QUALITY ASSURANCE -- NON-CONFORMANCE REPORT

Report No: NCR-000599

NCR #: ZPMC-0572

Reference Description: ZPMC performed weld repair on 3 Transverse Indications without the Engineer's approval in Segment 5BE

Component: OBG 5BE Deck Panel to Edge Plate

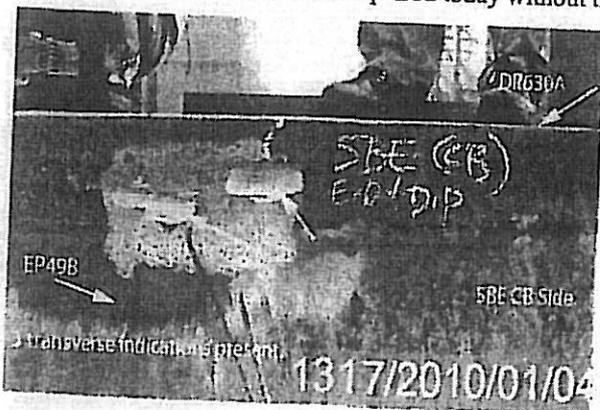
Reference Description: ZPMC performed weld repair on 3 Transverse Indications without the Engineer's approval in Segment 5BE

- ZPMC discovered three (3) transverse indications utilizing the Magnetic Particle (MT) method.
- Y location is approximately between 650~710mm measured from weld splice OBE5-006 on Cross Beam (CB) side.
- The Weld Joint is identified as: SEG24*-037 in Segment 5BE.
- The Edge Plate (EP) on the CB side of segment is identified as: EP49B
- The Deck Plate (DP) is identified as: DP630A.
- The steel material is designated as: A709 Grade 345 Seismic Performance Critical Member (SPCM).
- No approved welding procedure specification (WPS) was on site during the welding repair process.
- These excavation areas were repaired today without the prior approval of the Engineer.

Submit the correct WPS for these repairs. Do not initiate repairs without first notifying the engineer. A response for the resolution of this issue is expected within 7 days.
